Subject: Minutes of Meeting held on 27.10.2023 (Friday) at 11:30 AM to discuss w.r.t. new STATCOMs proposed to be installed at ISTS sub-stations – reg.

**Minutes of Meeting held on 27.10.2023 (Friday) at 11:30 AM to discuss requirement w.r.t. new STATCOMs proposed to be installed at ISTS sub-stations – reg.**

**Annexure-II**

**Figure 1: LVRT Curve as per CEA (Technical Standards for Connectivity to the Grid) Regulations for STATCOM**  
 (Voltages in the curve is the HV side voltages)

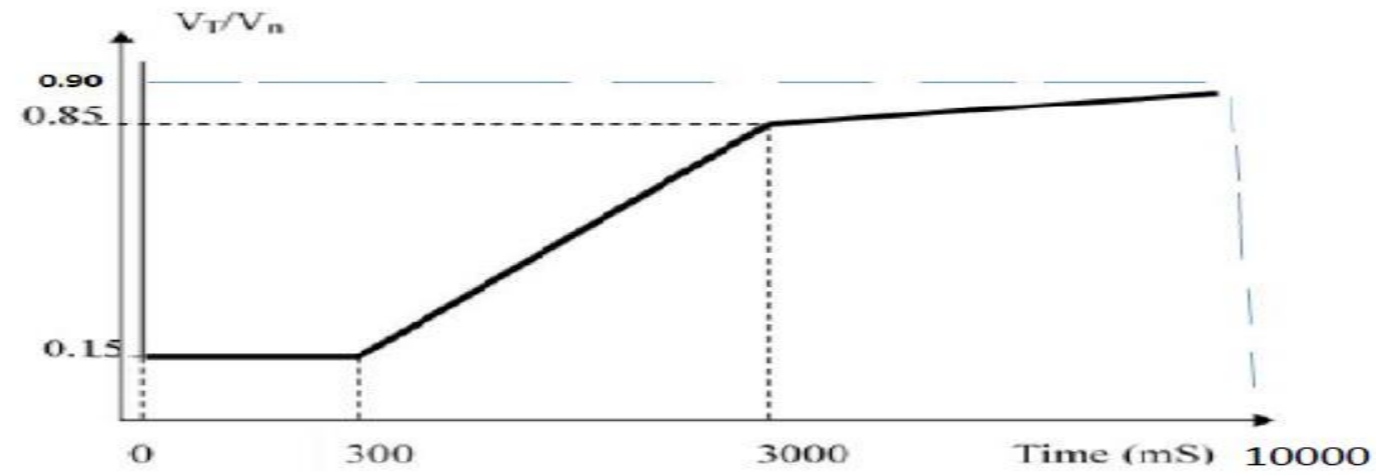
4.	LVRT Threshold value shall be coordinated with that of RE plant	Achievable to inject rated current if the voltage in all three phases goes below a level, but not greater than 0.135 pu.	Achievable. However, the LVRT and HVRT duration as per NERC PRC-024-2 document is given below in <b>Table 1</b> .	Achievable for 1-ph/3-ph faults. Not achievable for 2-ph faults which have less probability.	Achievable.	Acceptable if OEM can achieve the same. However, POWERGRID recommends for further studies if the requirement of IBR (at RE generation)	LVRT requirement shall be higher than that of IBR at RE generator.  STATCOM system may give all possible assistance at times of	In the LVRT, the threshold value shall be coordinated with that of RE plant as per the CEA (Technical Standards for Connectivity to the Grid) Regulations i.e.

S. No.	Topic	OEM Recommendation/Remark				POWERGRID Remark	CTUIL/ GRID India Remark	Recommendation of the Sub-committee
		HITACHI	HYOSUNG	SIEMENS	GE			
						needs to be complied for STATCOM connected at Grid Level (since STATCOM PCC is grid bus voltage and not generator bus voltage)	short term low voltage and high voltage. Illustrative time sequence diagrams providing concurrent voltage and current values versus time duration should be provided in RfP.	<p>the curve shown in <b>Figure 1</b> may be followed for STATCOM installed at ISTS near RE complexes.</p> <p><b>For locations other than RE complexes 0.3 pu for 5 sec may be taken as the lower limit.</b></p> <p>LVRT curve shows the minimum time to remain connected and deliver rated reactive power support.</p> <p>Further, as shared by OEMs, globally 0.3 p.u. is taken as the LVRT threshold value and rarely 0.2 p.u. based on the site specific conditions.</p>
